Agenda Item # 5

SUB-003822-2026

Kstylez Beauty Subdivision

- Subdivision approval to create one (1) legal lot of record from two (2) metes-and-bounds parcels.

DETAIL SITE PLAN

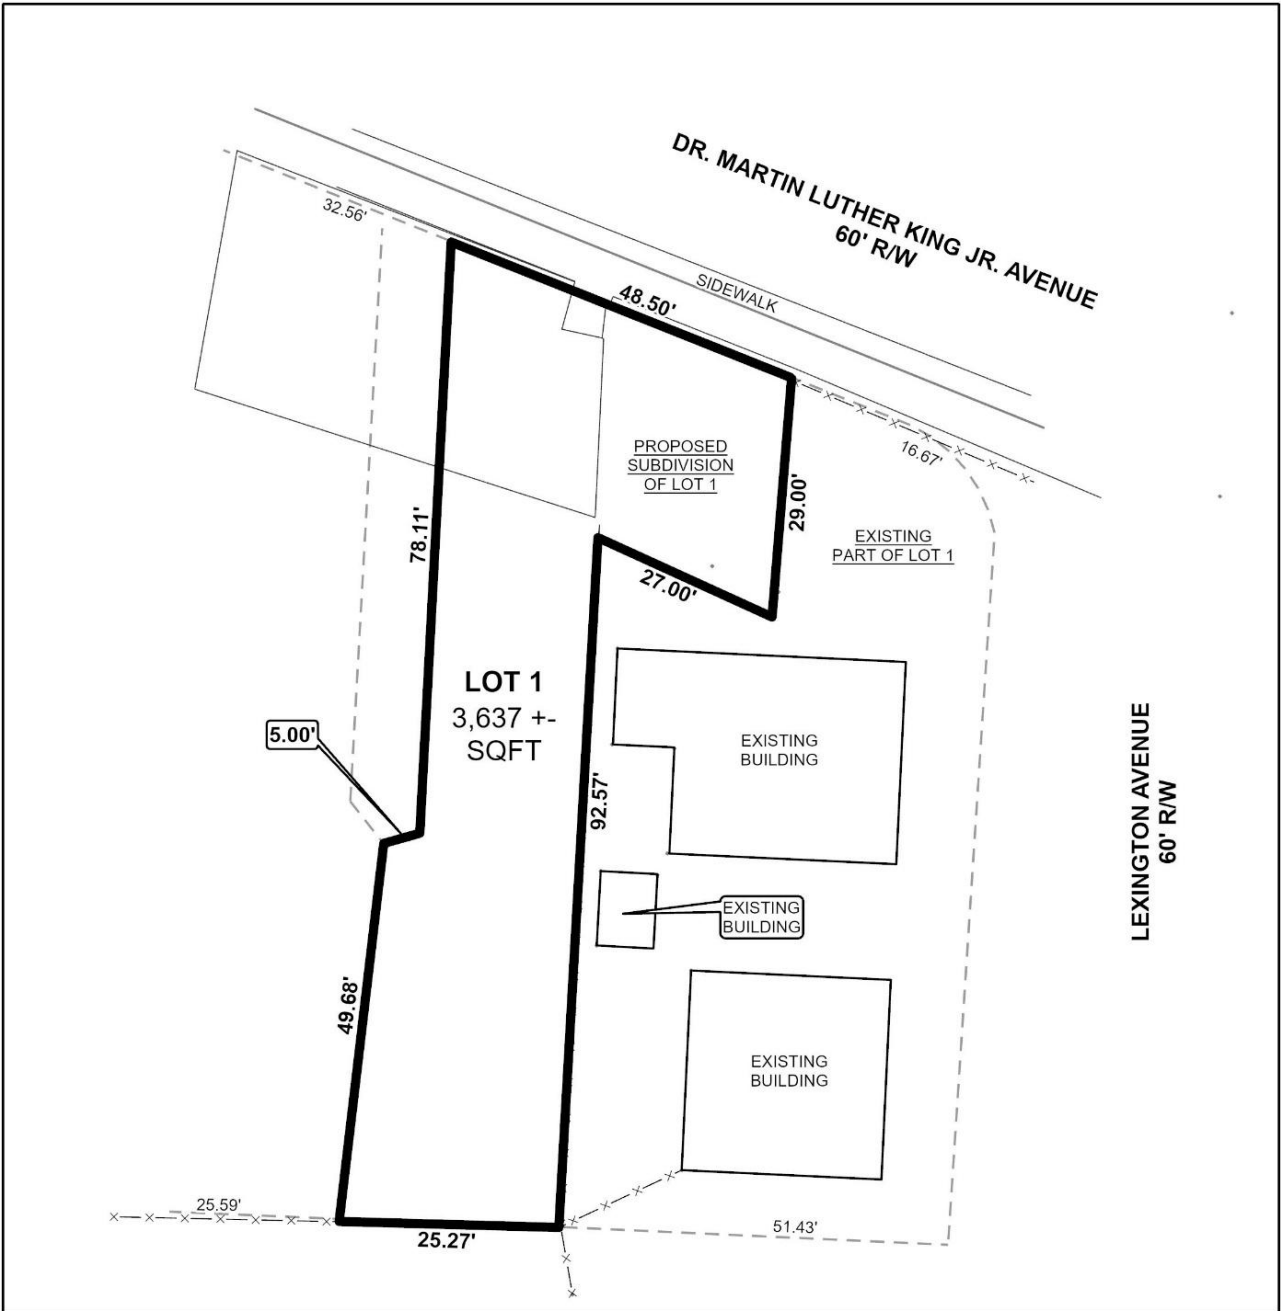
- B. Revise NOTES #13 to read "As shown on the 1984 aerial photo LOT 1 will receive the 1,800 sf of historical credit of existing (1984) impervious area towards stormwater detention requirement per Mobile City Code, Chapter 17, Storm Water Management and Flood Control) as follows: LOT 1 – 1,800 sf. Stormwater detention will be required for any additional impervious area that exceeds the allowable credit for that LOT.

- C. Retain NOTES 6 - 8, 12, & 15.
- D. Email a pdf copy of the FINAL SUBDIVISION PLAT and LETTER OF DECISION to the Permitting Engineering Dept. for review at land.disturbance@cityofmobile.gov prior to obtaining any signatures. No signatures are required on the drawing.

The proposed lot has frontage along Dr. Martin Luther King Jr. Ave, a minor arterial street requiring a 60-foot-wide right-of-way at this location. The right-of-way along Dr. Martin Luther King Jr. Ave on the preliminary plat is showing 28.9 feet and 29.2 feet; therefore, if approved, the plat should be revised to illustrate right-of-way dedication sufficient to provide 30 feet from the centerline of Dr. Martin Luther King Jr. Ave.

The proposed lot does not meet the minimum width requirements of Section 6.C.2.(b)(4) of the Subdivision Regulations for commercially zoned properties, the minimum of which is 60 feet. The lot also does not meet the minimum area requirements of Article 2, Section 64-2-13.E. of the Unified Development Code (UDC) for lots served by public water and sanitary sewer within the B-2, Neighborhood Business Urban District. As such, waivers of Section 6.C.2.(a)(1) and Section 6.C.2.(b)(4) of the Subdivision Regulations will be necessary for approval.

The lot is properly labeled with its area in both square feet and acres on the preliminary plat. If approved, this information should be retained on the Final Plat, adjusted for any required dedication; alternatively, a table providing the same information will suffice.

If approved, the plat should be revised to illustrate a 25-foot front yard setback along Dr. Martin Luther King Jr. Avenue, in accordance with Article 2, Section 64-2-13.E. of the UDC and Section 6.C.8. of the Subdivision Regulations, adjusted for any required dedication.

1. Revision of the plat to illustrate dedication sufficient to provide 30 feet from the centerline of Dr. Martin Luther King Jr. Ave;
2. Retention of the lot's size in both square feet and acres, adjusted for any required dedication, or the provision of a table on the Final Plat providing the same information;

3. Revision of the Final Plat to illustrate the required 25-foot front yard setback along Dr. Martin Luther King Jr. Ave, in compliance with Article 2, Section 64-2-13.E. of the UDC and Section 6.C.8. of the Subdivision Regulations, adjusted for any required dedication;
